SOUTHERN REGIONAL PLANNING PANEL

COUNCIL ASSESSMENT REPORT

| DA Number | DA23/1070 (PAN-318835) |
| Proposed Development | Demolition works, construction of a 3-storey residential flat building containing 50 apartments above one level of basement parking with 73 car spaces, with subsequent strata subdivision. Forty (40) of the apartments are to be dedicated for affordable housing. |

Figure 7 – Proposed First Floor Plan (Source: Coble Stephens Architects)

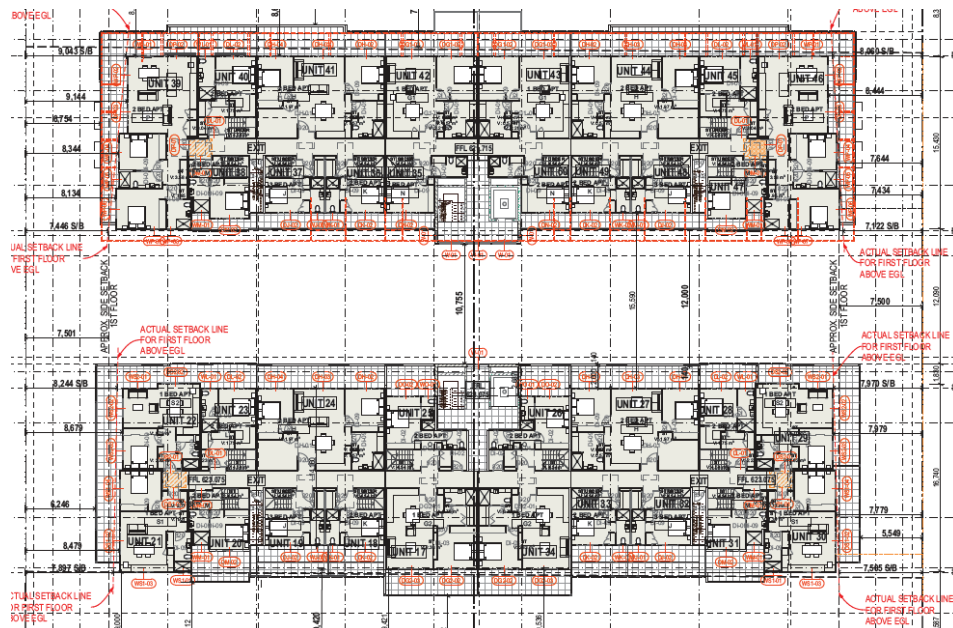
- i. A minimum 12m building separation is to be provided between balconies up to 4 storeys. It is noted from the plans that 11m is provided between balconies on the first floor. The proposal is to be amended to comply.

- Northern building resituated 170mm to north to increase central courtyard width.
- Reduction in depth of southern terraces to first floor of northern building increase building separation to minimum 12 metre requirement.
- Southern building lift in levels results in level change to courtyard – improved sunlight access.

Figure 8 – Proposed Second Floor Plan (Source: Coble Stephens Architects)

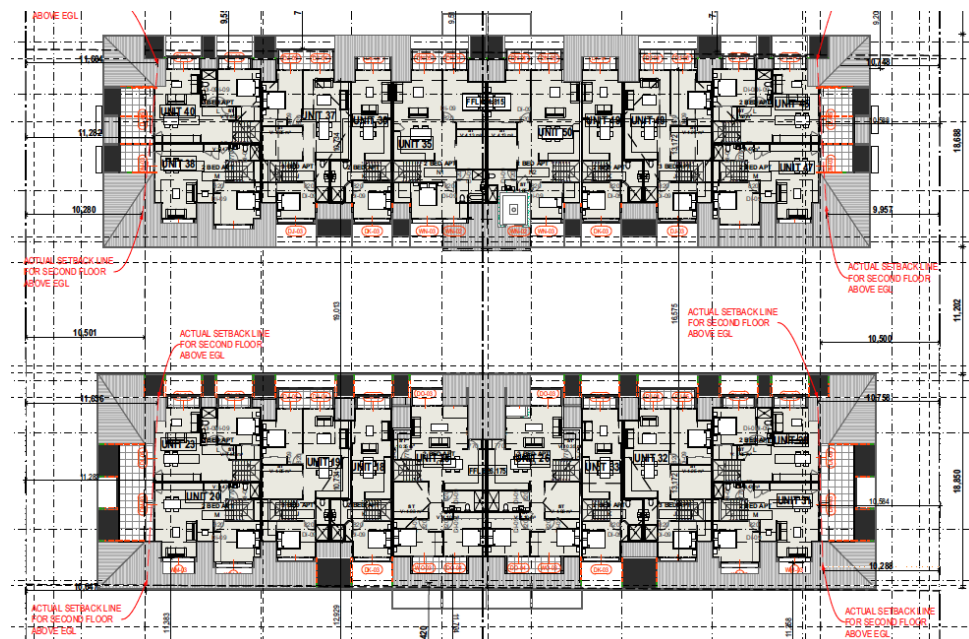
The proposal should consider other design solutions to minimise opportunity for overlooking and impacts on privacy. These may include, but are not limited to, solid balustrades and screening devices.

- Privacy screens incorporated on second floor balconies to east, west and northern facades.
- Privacy screens incorporated on first floor western facades. No privacy screens to first floor due to existing heavy screen planting on neighbouring boundary to be retained.
